**Subject:** RE: 110412 FAI 037 Safety Project D5 Requests Signed Appraisal Checklists  
**Attachments:** 110412 FAI 037 PCL 011 Appraisal Scoping Checklist Reviewed.pdf; 110412 FAI 037 PCL 009 Appraisal Scoping Checklist Reviewed.pdf; 110412 FAI 037 PCL 008 Appraisal Scoping Checklist Reviewed.pdf; 110412 FAI 037 PCL 006 Appraisal Scoping Checklist Reviewed.pdf; 110412 FAI 037 PCL 004 Appraisal Scoping Checklist Reviewed.pdf; 110412 FAI 037 PCL 001 Appraisal Scoping Checklist Reviewed.pdf; 110412 FAI 037 PCL 020 Appraisal Scoping Checklist Reviewed.pdf; 110412 FAI 037 PCL 018 Appraisal Scoping Checklist Reviewed.pdf; 110412 FAI 037 PCL 017 Appraisal Scoping Checklist Reviewed.pdf; 110412 FAI 037 PCL 015 Appraisal Scoping Checklist Reviewed.pdf

**Subject:** RE: FAI-37-6.34 Preliminary Right of Way Plans (PID No. 110412)

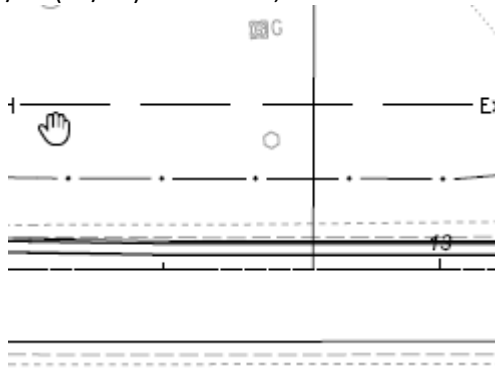
- Missing sheet 20 of 37 as Luke stated.
- Page 21/36 (22/37) Parcel 11-SH shows "Utility Pole Save" for private light poles. I would have them removed as ODOT will need to pay for them anyways (in take area) and would need to do a permit (not recommended) for the poles that are very close to the fence needing removed. Same Parcel has three of those poles (not 2) and also has a small sign near the fence that was not picked up on these plans:
